Written Submission on draft Amendment C244melt and accompanying document

Parcel ID: 17

We are writing to the Victorian Planning Authority (VPA) in **objection to the placement of the following encroaching on the rear of our property boundary.**

APPENDIX
1.

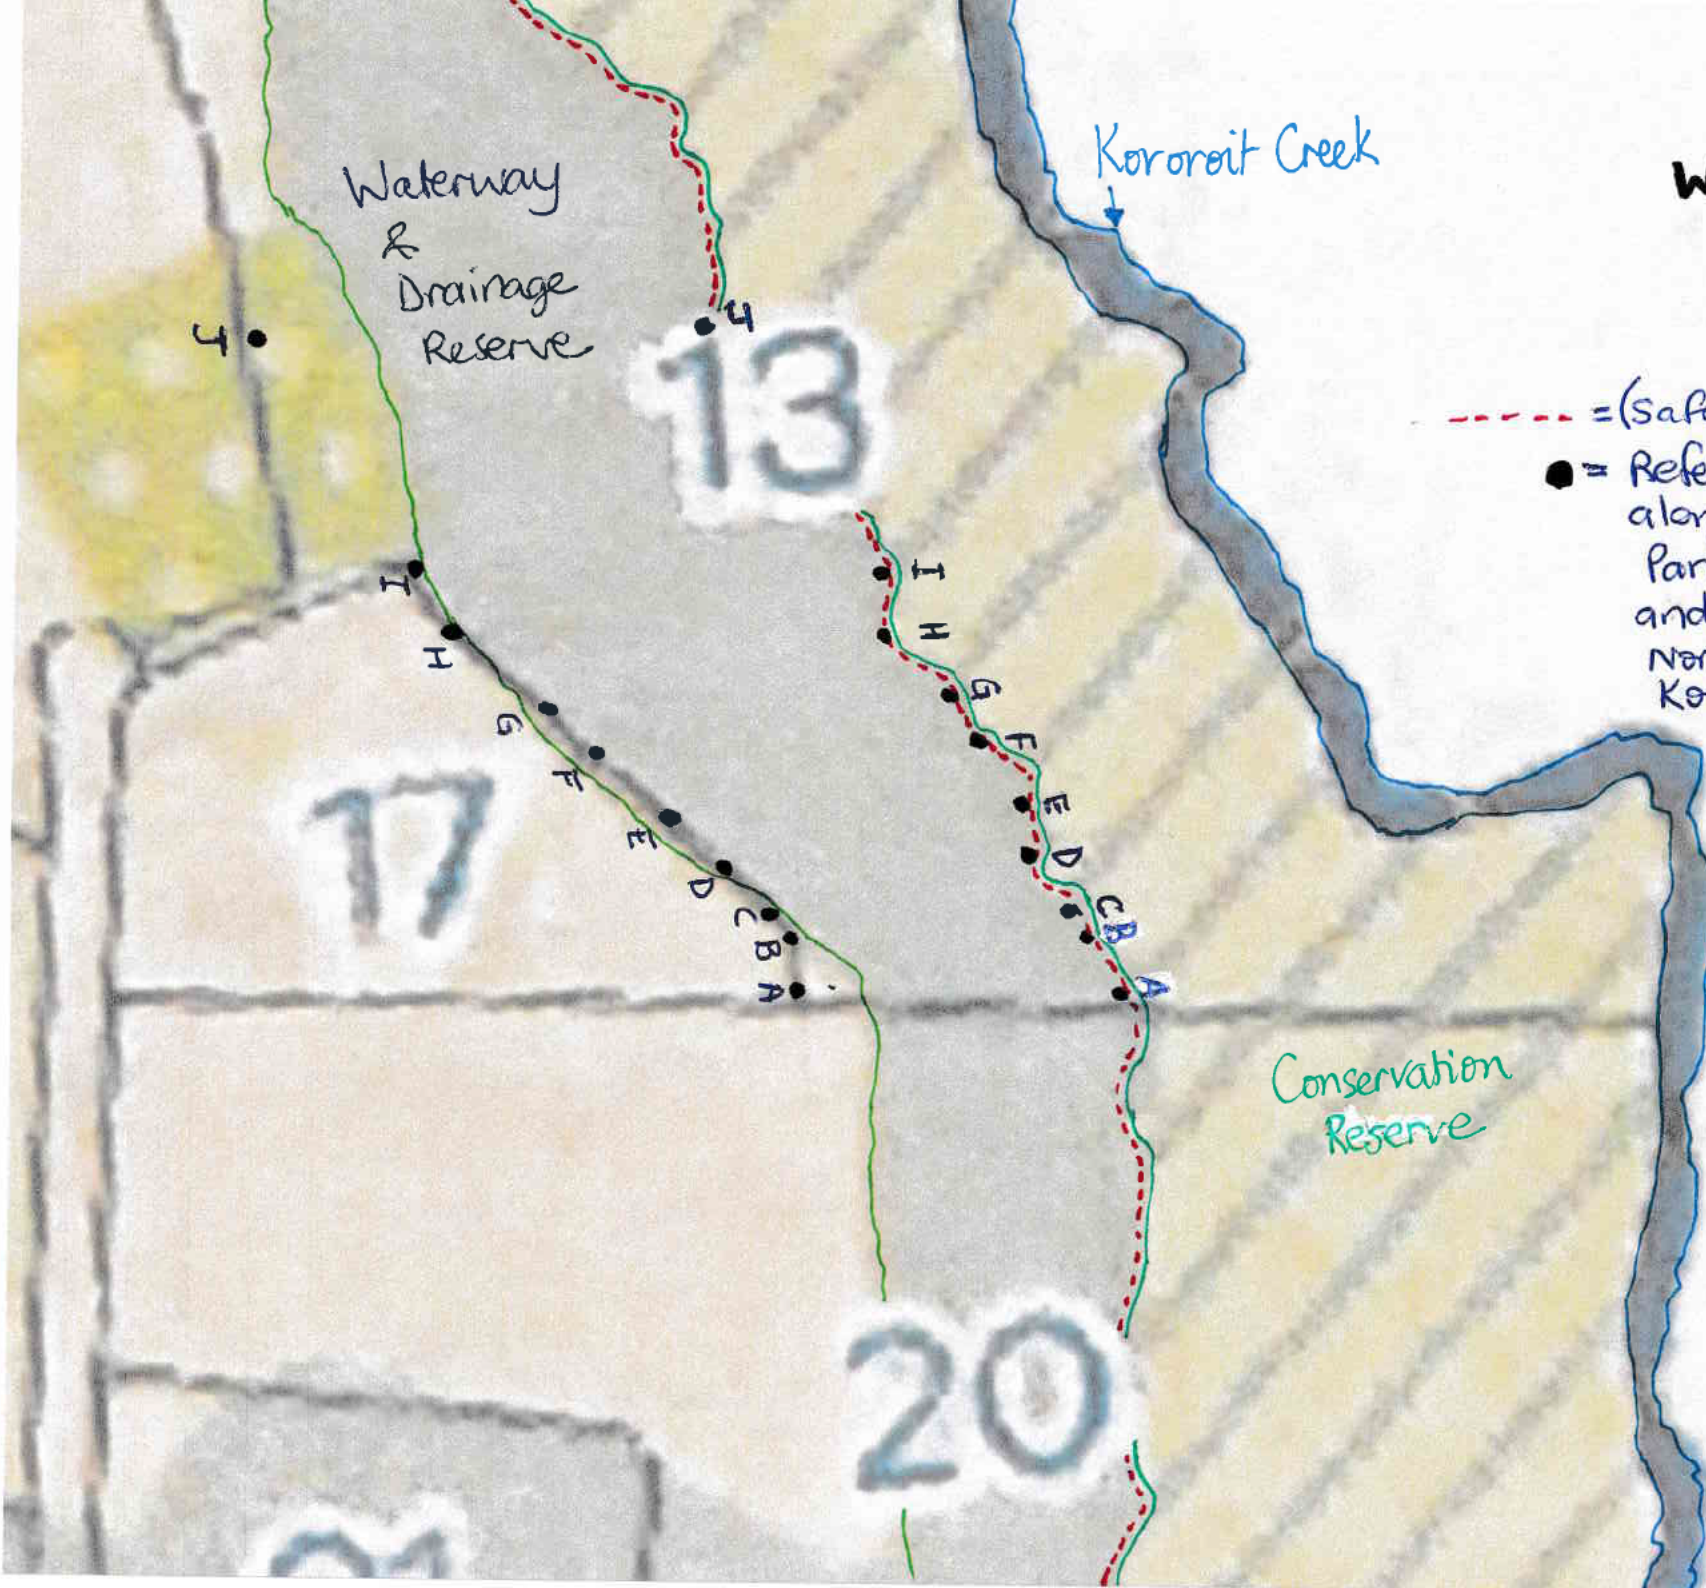
- On 16th March 2025, we manually carried out a number of measurements from our boundary to the escarpment, using a counter measuring wheel. *(an allowance of an

- We provide a series of reference point photos along the boundary to the escarpment, in support of our measuring technique as proof of conduction. **APPENDIX 1. & 2.**

As Melbourne Water has assessed the appropriate setback for Kororoit Creek at this location, and has adopted a 30m setback. Shown in our **Table 1.** you can see that the minimum distance from our boundary to the escarpment is **32m** *(not including the 1-2m safety zone allowance for the operator while carrying out the investigation).

In our site analysis, we surveyed the land using laser level equipment to identify the slope in % from the (North-East) Kororoit Creek back boundary to the break of slope (escarpment). It was found at the shortest distance; point **F**, being **(32m)** this had the highest value, being; **5.25% slope**. The general, overall, landscape beyond our property boundary to the escarpment and that of our neighbours; Parcel ID. 13 and 20 is relatively flat. **refer to APPENDIX 4. & Table 1.** Also showing that our neighbouring parcels (Parcel ID. 13 & 20) meet the requirements of the 30m adopted setback by Melbourne Water.

We request the removal of the (DSS) waterway and the off-road shared path and the off-road two-way bike path from our NET DEVELOPABLE AREA (Parcel ID. 17). We strongly believe that there is more than sufficient, available flat, safe, land as we have measured distances 40m and beyond as substantiated. This meets Melbourne Waters' 30m setback for the DSS Waterway Drainage Corridor placement requirement. We feel it is reasonable and supported with our professional findings and evaluations carried out in person, and not based on criteria via LIDAR system of its initial origin.

We suggest that the installation of re-enforced concrete piping is used to direct the pathway of water underground through the acquired Parcels' ID 12, 16 & 19 to connect to the Basin Water Reserve. This will overcome the following issues; access, safety, expensive bridge crossings cost and ongoing open waterway maintenance.

Regards to, the off-road shared path and the off-road two-way bike path placement these can be safely co-located in that corridor (Waterway & Drainage Reserve). This is not uncommon practice for co-location of off-road shared path ways and two-way bike paths, to be co-located within Water & Drainage Reserves. It is unfair that the responsibility of the maintenance is to fall upon the private owner; (developer) to maintain an indicative Council asset, rather than the Melton Council being solely and rightly responsible for this community shared asset.
